# RESPONSES TO COMMENTS ON THE DRAFT ENVIRONMENTAL IMPACT REPORT

## SFPUC Alameda Creek Recapture Project Volume 3

PLANNING DEPARTMENT  
CASE NO. 2015-004827ENV  
STATE CLEARINGHOUSE NO. 2015062072  
JUNE 7, 2017

Re: **Responses to Comments on the Draft Environmental Impact Report for  
Case No. 2015-004827ENV, SFPUC Alameda Creek Recapture Project**

SFPUC Alameda Creek Recapture Project  
**Revised Figure 3-2**  
 Project Vicinity Map

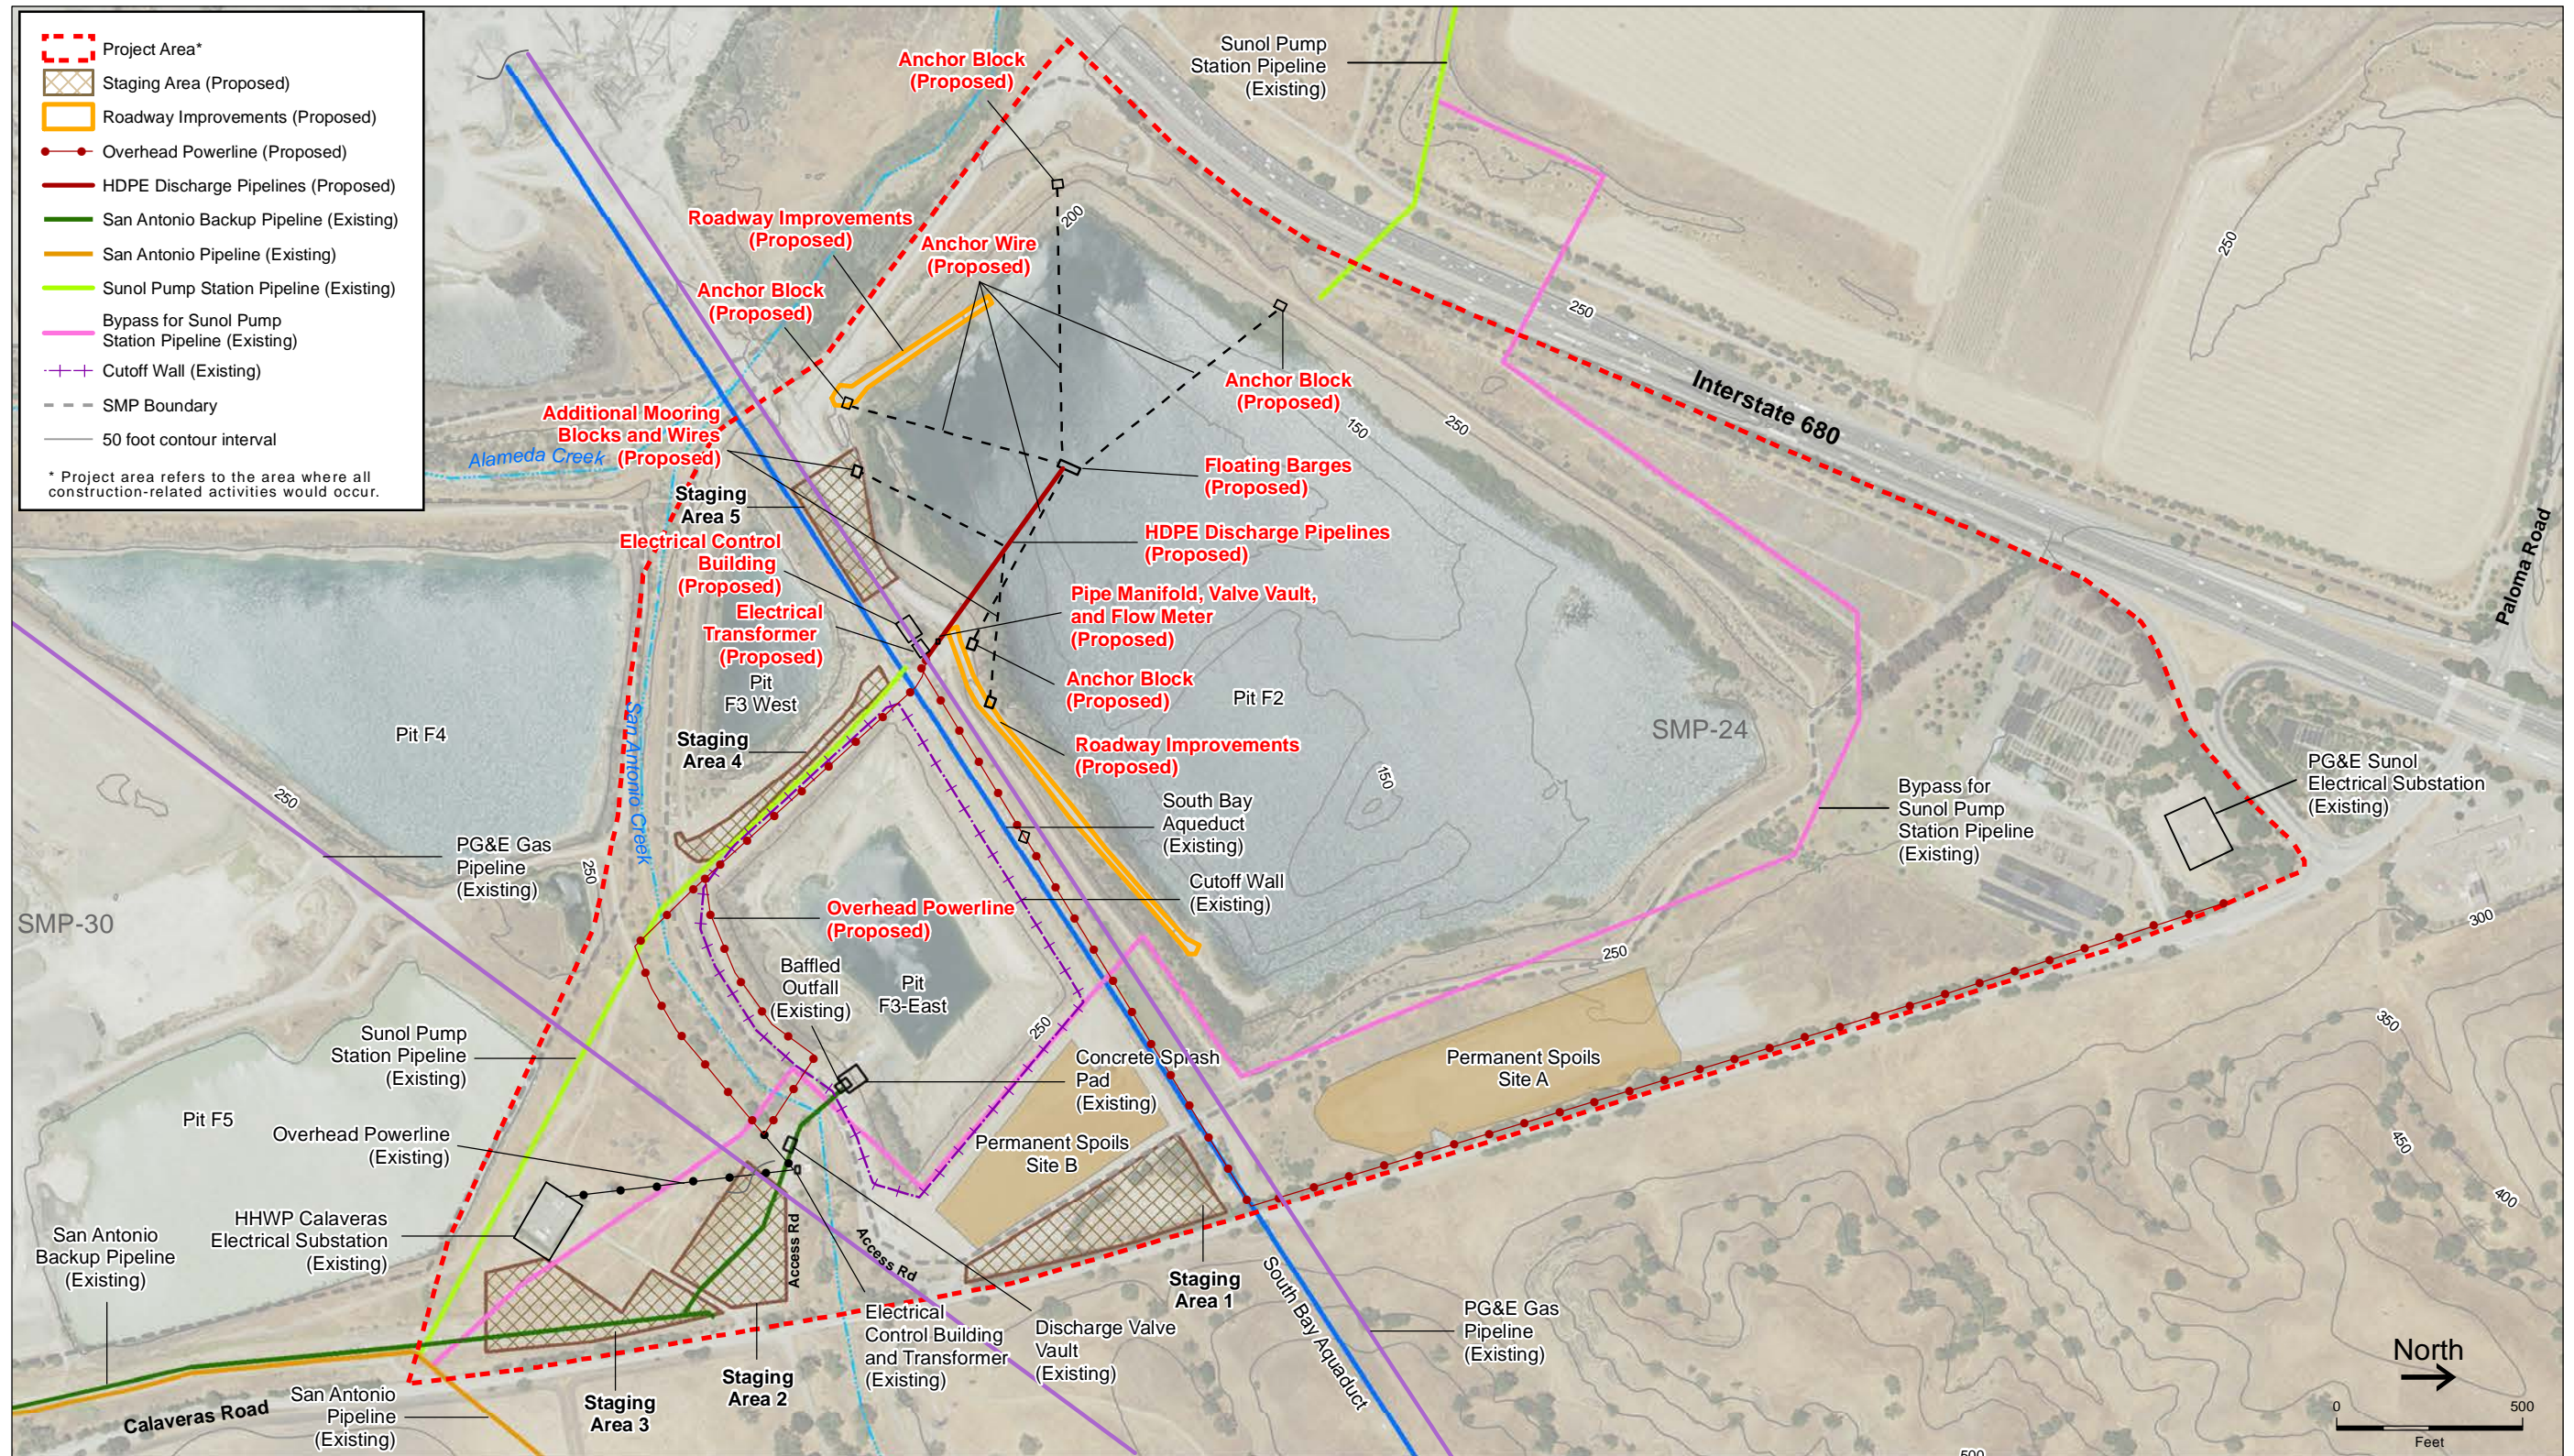
f. **The DEIR cumulative impacts do not include effects of cutoff walls.** Figure 1-1 of the DEIR displays existing cutoff walls around Pit F2, which were installed to minimize seepage of Alameda Creek surface water into the groundwater basin and into Pit F2. The figure also displays proposed future cutoff walls around sections of Pit F6. Installation of this future cutoff wall will likely provide additional protection from surface streamflow losses to the Sunol groundwater basin. The hydrologic analysis must be refined to include the proposed cutoff wall, and any associated changes in streamflow loss rate to determine cumulative impacts and adequately model future streamflow conditions through this reach (CEQA Guidelines §§ 15065(a)(3), 15130). (Robert Shaver, General Manager, Alameda County Water District, January 30, 2017, A-ACWD2-10)

As discussed in Response HY-9, Figure 3-2, page 3-5, has been revised to remove the proposed cutoff wall because it currently does not exist, as shown on page 12-7. See Revised Figure 3-2.
